# UNITED STATES PATENT AND TRADEMARK OFFICE

APPLICATION NO.	FILING DATE	FIRST NAMED INVENTOR	ATTORNEY DOCKET NO.	CONFIRMATION NO.
10/581,415	06/02/2006	Ulrich Maier	R.305913	3724
2119	7590	10/29/2009	EXAMINER	
RONALD E. GREIGG			BROWN, PHYLLIS M	
GREIGG & GREIGG P.L.L.C.				
1423 POWHATAN STREET, UNIT ONE			ART UNIT	PAPER NUMBER
ALEXANDRIA, VA 22314			3753	
			MAIL DATE	DELIVERY MODE
			10/29/2009	PAPER

<b>Office Action Summary</b>	<b>Application No.</b>	<b>Applicant(s)</b>	
	10/581,415	MAIER ET AL.	
	<b>Examiner</b>	<b>Art Unit</b>	
	MACADE BROWN	3753

## **DETAILED ACTION**

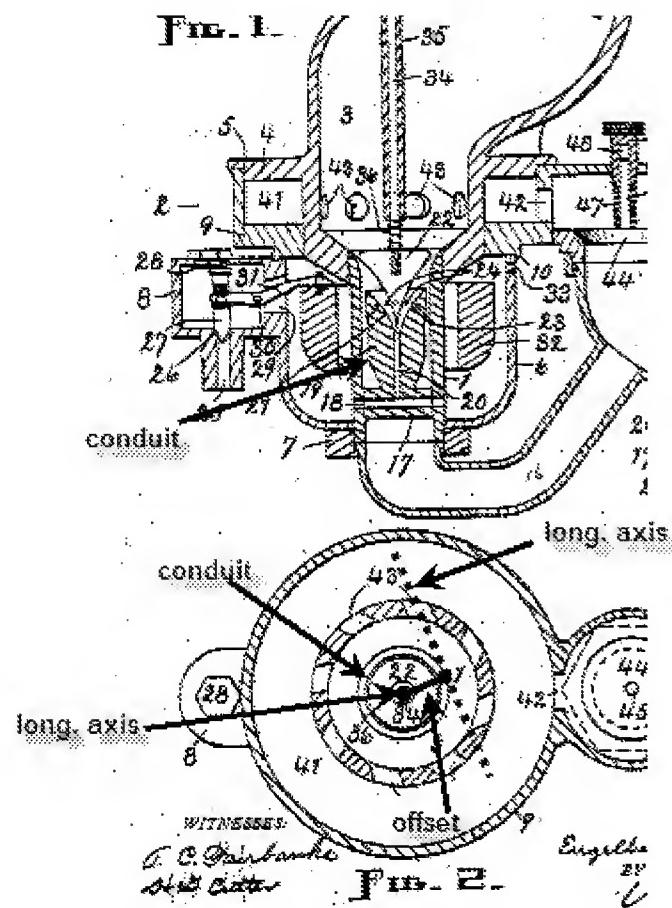
Hanemann teaches, as best understood, the fluid conduit (includes unreferenced conduit and conduit 43; see fig. 1 below) a has a substantially constant width and is embodied such that a rotation about the longitudinal axis of the fluid conduit is impressed on the fluid stream that flows toward the valve chamber, without a constriction of this fluid stream being produced; and the longitudinal axis of the first conduit portion 43 being laterally offset from the longitudinal axis of the second conduit portion (fig. 2 below); the lateral offset of the longitudinal axes is greater than the radius (the offset of the two axes is greater than the radius of conduit portion 43; also see fig. 2 below); further including a transition region 3 (chamber) between the first conduit portion 43 and the second conduit portion; wherein the transition region includes a wall (chamber wall) that is curved from the first conduit portion to the second conduit portion 43 [Note: the patentability of a product does not depend on its method of production, i.e. electrochemical removal. If the product in the product-by process claim is the same as or obvious from a product of the prior art, the claim is unpatentable even though the prior product was made by a different process. *In re Thorpe*, 777 F.2d 695, 698, 227 USPQ 964, 966 (Fed. Cir. 1985)], to provide a tangential discharge, equally and uniformly over the valve seat, preventing localized erosion or wear of the valve, and preventing shock and deflections that tend to interfere with the valve seating and sealing functions.

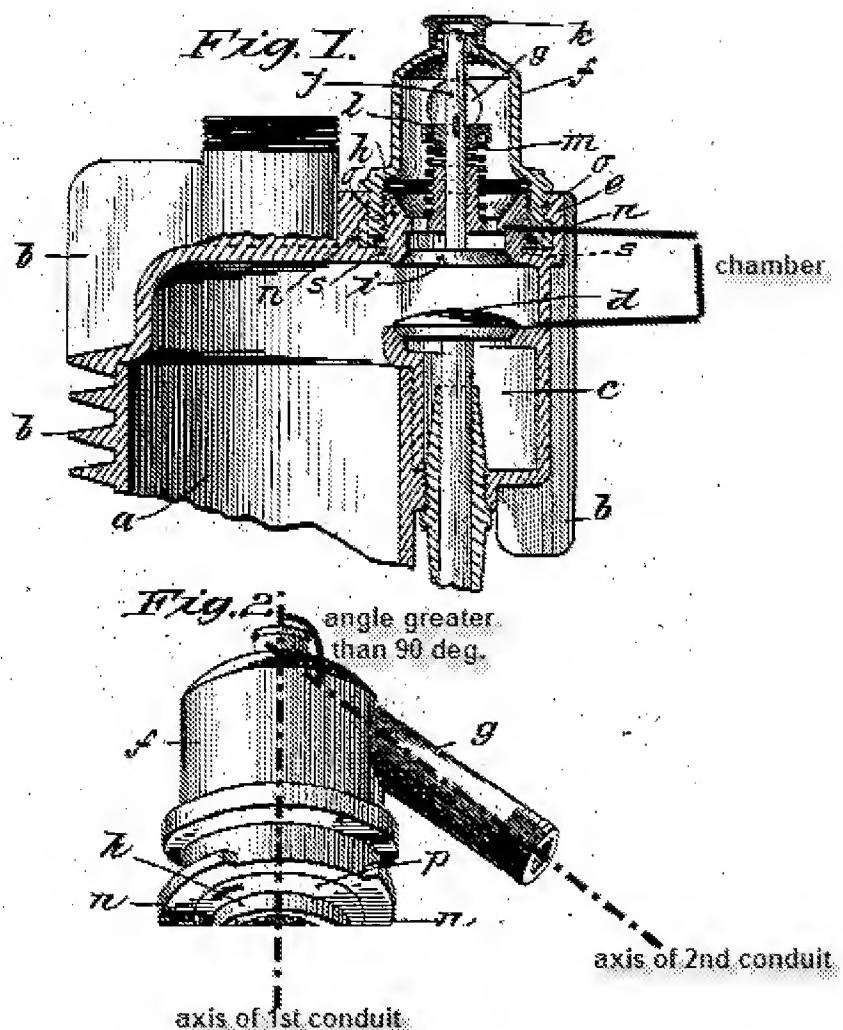
Regarding claims 10, 11, and 29, as best understood, Hedstrom teaches an inlet valve assembly including a valve element (i; fig. 1) disposed in a valve chamber 20 (see fig. 1 below) and a fluid conduit (g/f) adjoining the valve chamber on the upstream side, the valve element (i) alternatively opening and closing the fluid conduit (g/f) on the upstream side of the valve chamber, the fluid conduit (g/f) has a substantially constant width (the width of each individual conduit is constant); wherein the fluid conduit (g/f) comprises a first conduit portion (g) and a second conduit portion (f) adjoining the first conduit portion (g), the longitudinal axes of the first and second conduit portions being at an angle less than 180° to one another (fig. 2); the longitudinal axis of the first conduit portion (g) and the longitudinal axis of the second conduit portion (f) form an angle greater than 90° (see portion of fig. 2 below).

Hanemann teaches, as best understood, the fluid conduit (see fig. 1 above) a has a substantially constant width and is embodied such that a rotation about the longitudinal axis of the fluid conduit is impressed on the fluid stream that flows toward

the valve chamber (see fig. 2 above), without a constriction of this fluid stream being produced; and the longitudinal axis of the first conduit portion 43 being laterally offset from the longitudinal axis of the second conduit portion (fig. 2); the lateral offset of the longitudinal axes is greater than the radius (the offset of the two axes is greater than the radius of conduit portion 43; also see fig. 2 above).
